Subject: Data Response, Set 2D-2
Hidden Hills Solar Electric Generating System (11-AFC-2)

Hidden Hills Solar Electric Generating System (HHSEGS)

**Data Response, Set 2D-2
(Response to Data Requests
158 – 165, and 167- 171)**

FIGURE DR161-1
3-D Flux Map Model on Cylindrical Area
in the Solar Field at Maximum Load
(Maximum Flux Requirement),
Flux Density >10 kW/m²

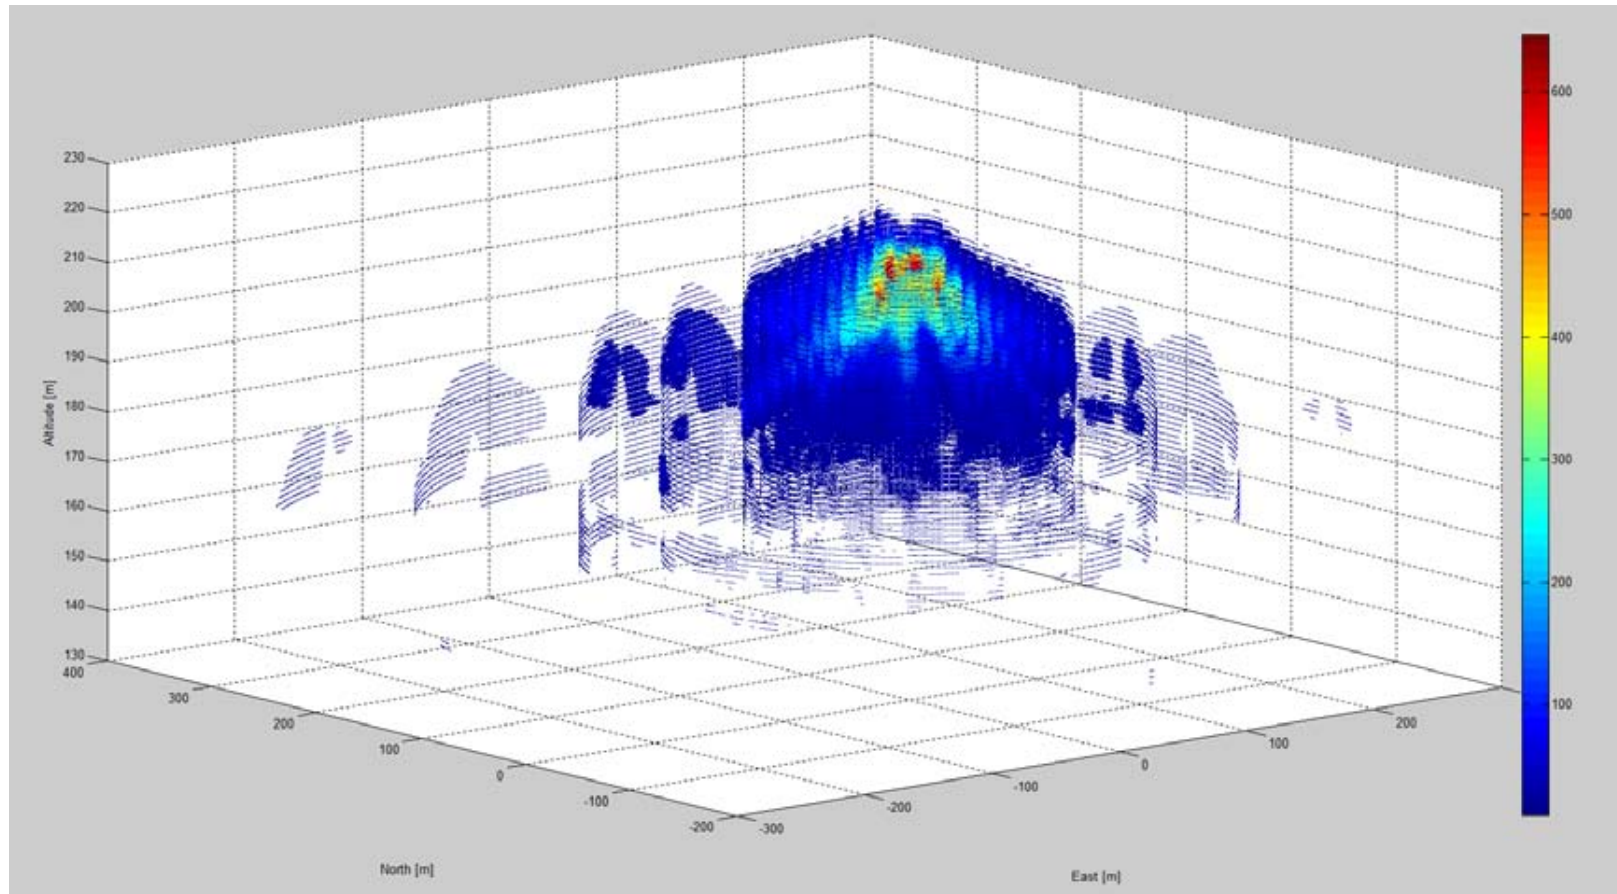
161. Please provide four diagrams in profile view of reflected solar flux, each should be modeled at 100% of project output. The diagrams must depict clearly, in kw/m², solar flux from power tower to heliostats. Please provide a diagram for reflected solar flux from heliostats at the following four locations: closest to power tower 1, furthest from power tower 1 (approximately 7,700 feet), closest to power tower 2, and furthest from

The side views show the highest value projections: note that views from the north and south are mirror images (as are those from east and west). Figure DR161-1 (figures are at the end of this data response) provides a 3-D view of the model output.
